## SB, Fuel cooler bracket, FS 7000, 2018-06

To prevent damage from vibrations a Radiator assy fuel cooler bracket kit is now available for the fuel cooler on FS 7000. A bracket is mounted on the radiator frame to hold the fuel cooler in place and minimize movement.

Figure 1:

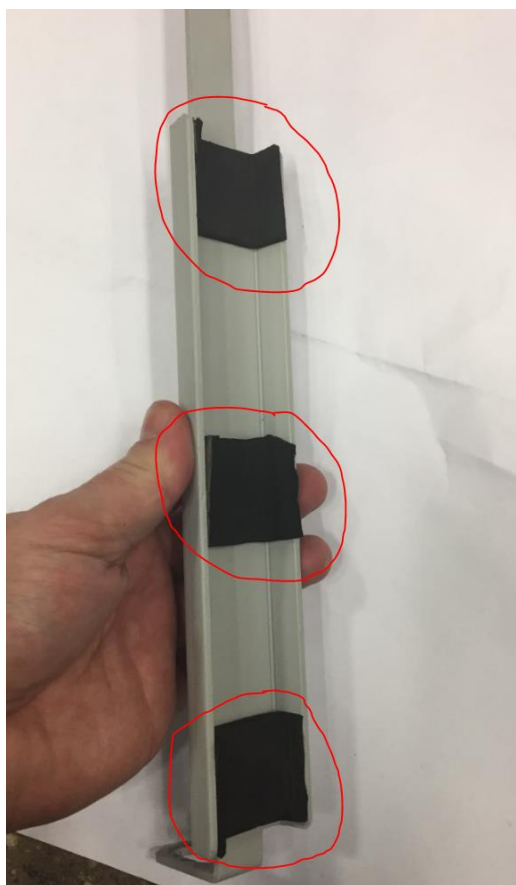
1. There are 3 pcs of foam included in the kit, apply them on the inside of the bracket (see figure 1).

Figure 3:

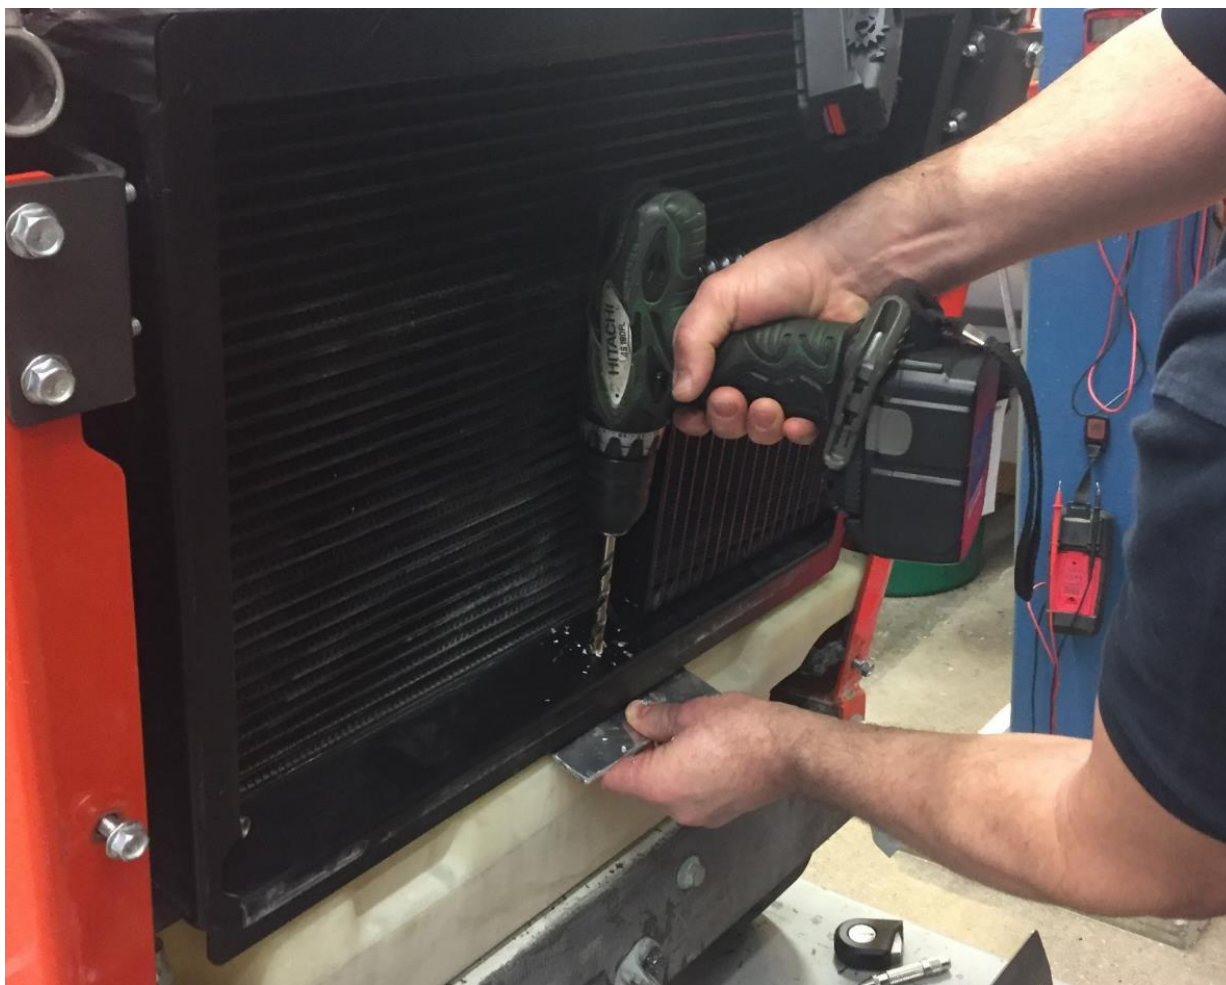
3. Drill 2 holes with a 9mm drill bit. Use a protection plate to prevent drilling through the fuel tank (see figure 3).

Figure 4:

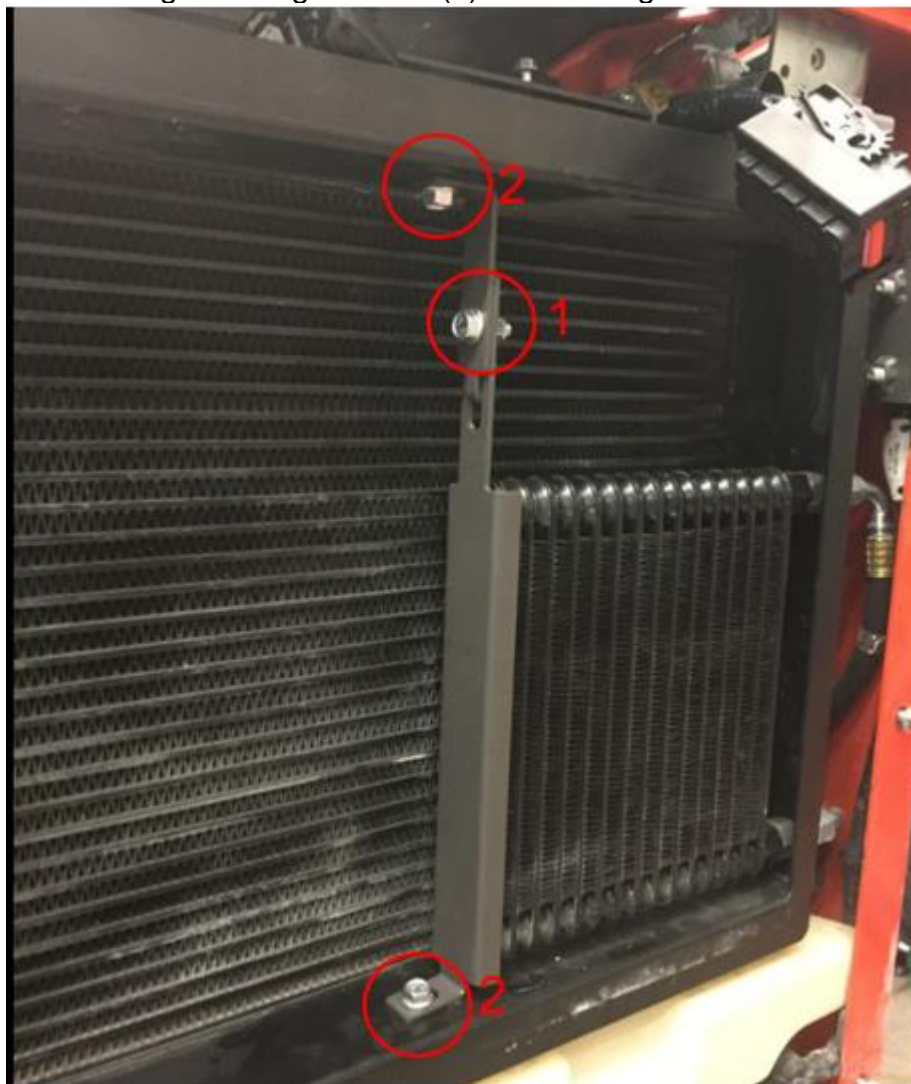
4. Mount the bracket with the M8 bolts included in kit (see figure 4).  
Set the length and tighten bolt (1) and then tighten the bolts to cooler (2).
